# **Yukon Zinc Corp.**

**Wolverine Mine**

***Dam Safety Review***

***Tailing Storage Facility and Earth Structures***

**Figure 2.1 Wolverine Mine – Operations Organization Chart (outdated) – Main Reporting Links**

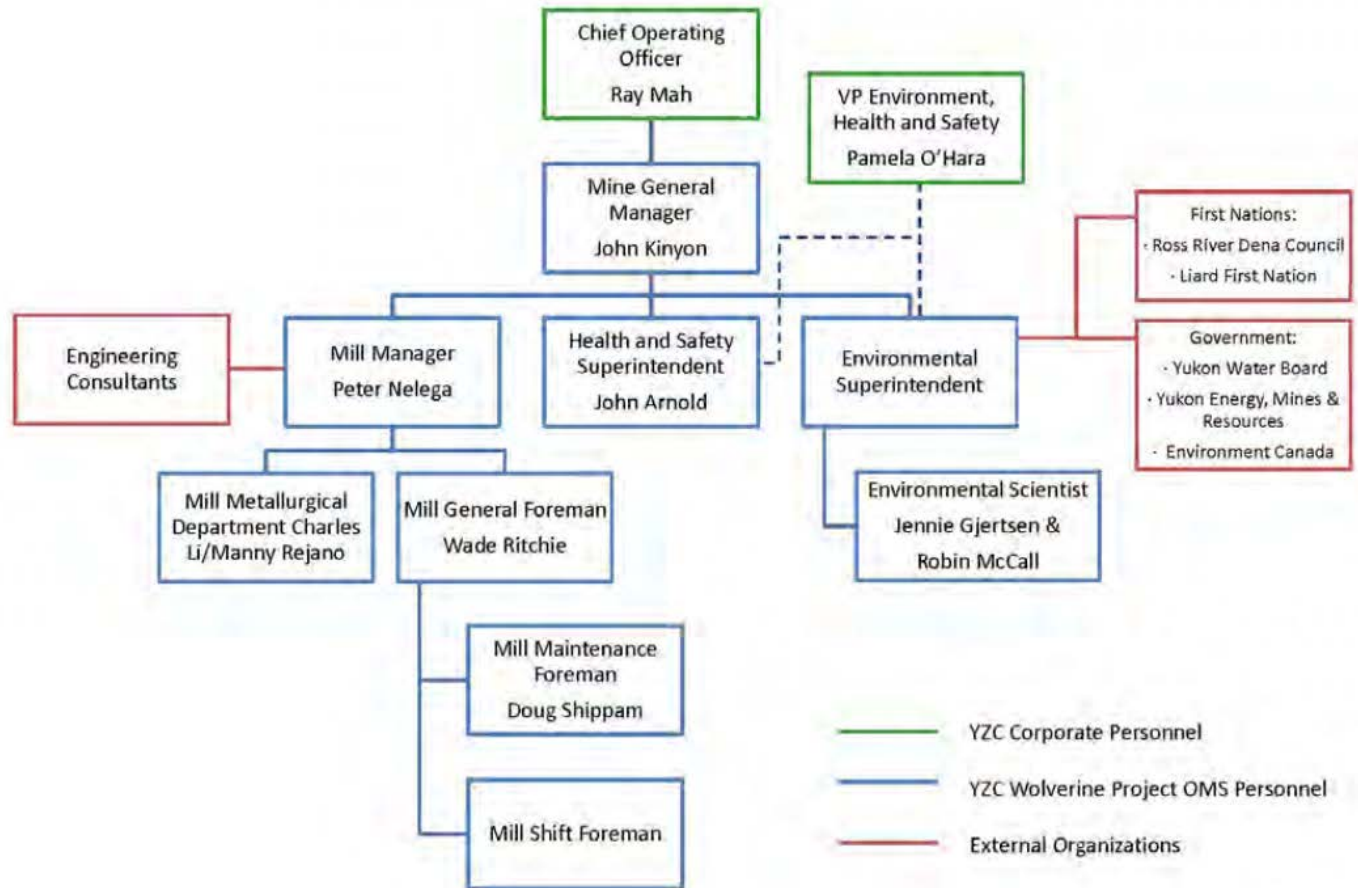
The organization structure for management of the tailings facilities is presented on Figure 2.1, but is out of date. This should be updated to reflect the current status of the operation. The OMS manual needs to be revised to reflect the current status of the mine in care and maintenance. It should also be updated again once decisions are made on whether the mine transitions back to operation or to closure.

**Figure 4.1 Stability Analysis**

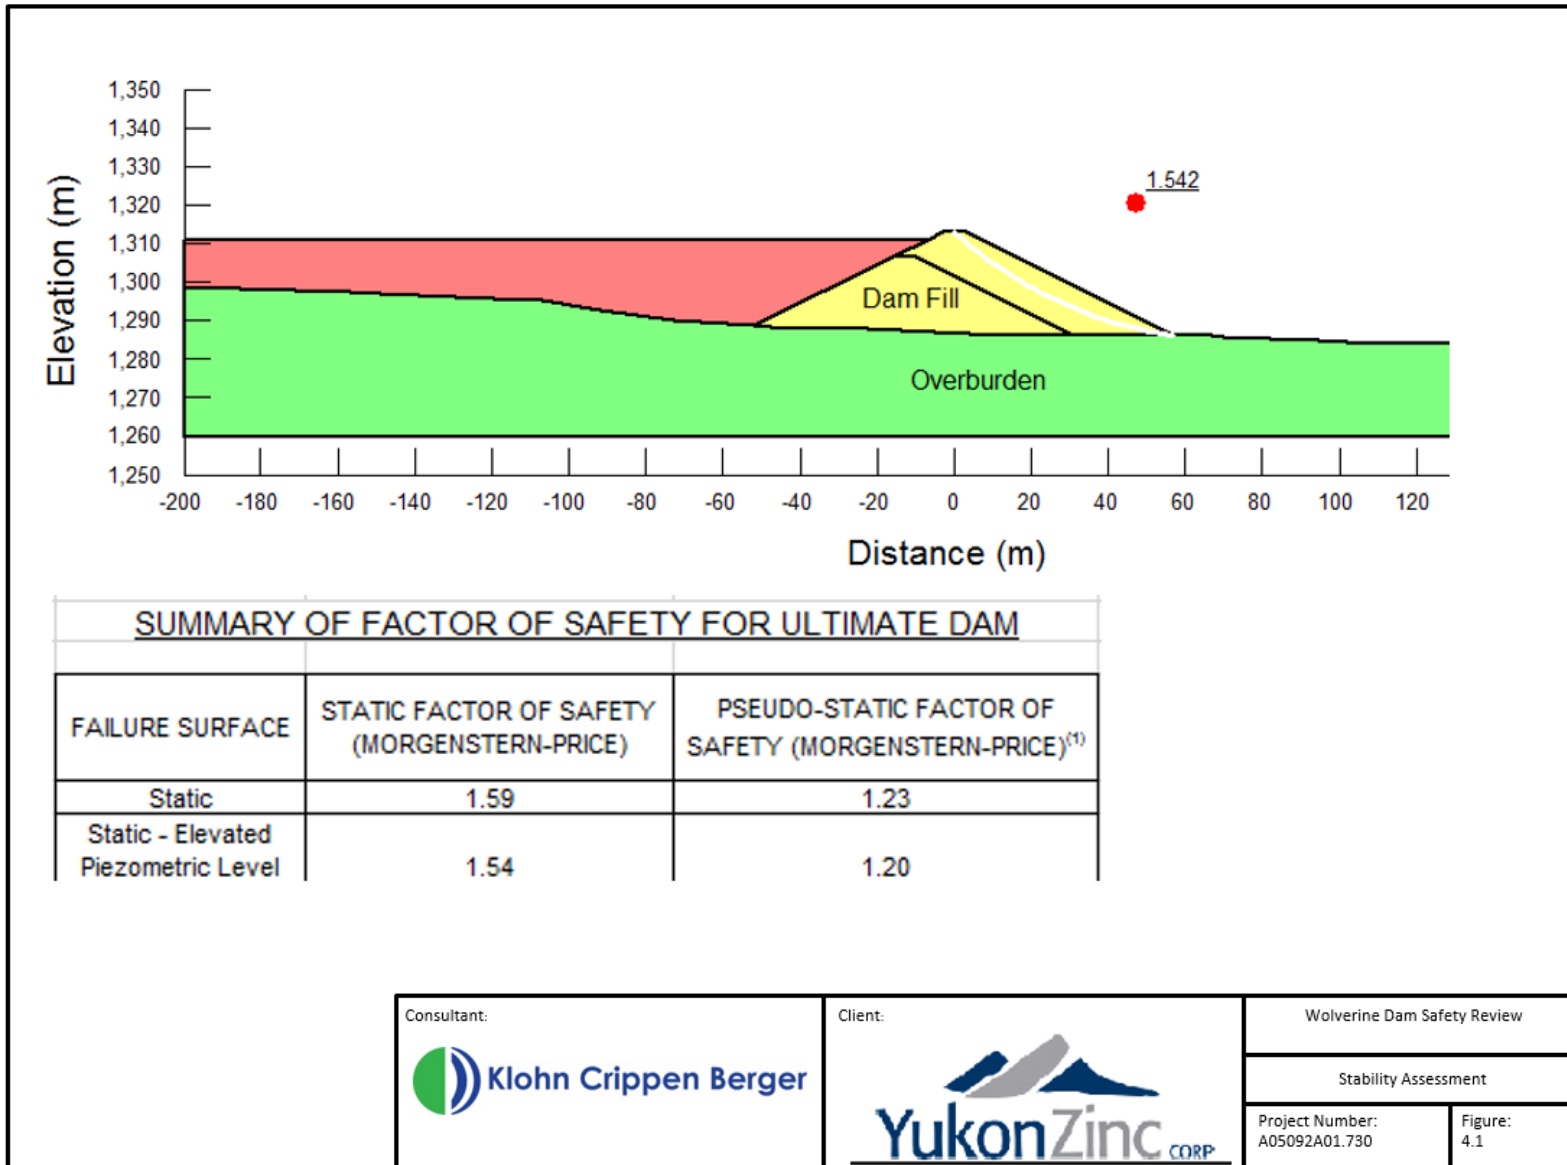
The stability of the dams was confirmed by a limit equilibrium stability analysis using the computer program Slope/W. The model geometry, material properties and analysis results are presented in Figure 4.1 and the factors of safety are summarized in Table 4.2. The analysis was carried out to check the stability and to review the sensitivity groundwater elevation.
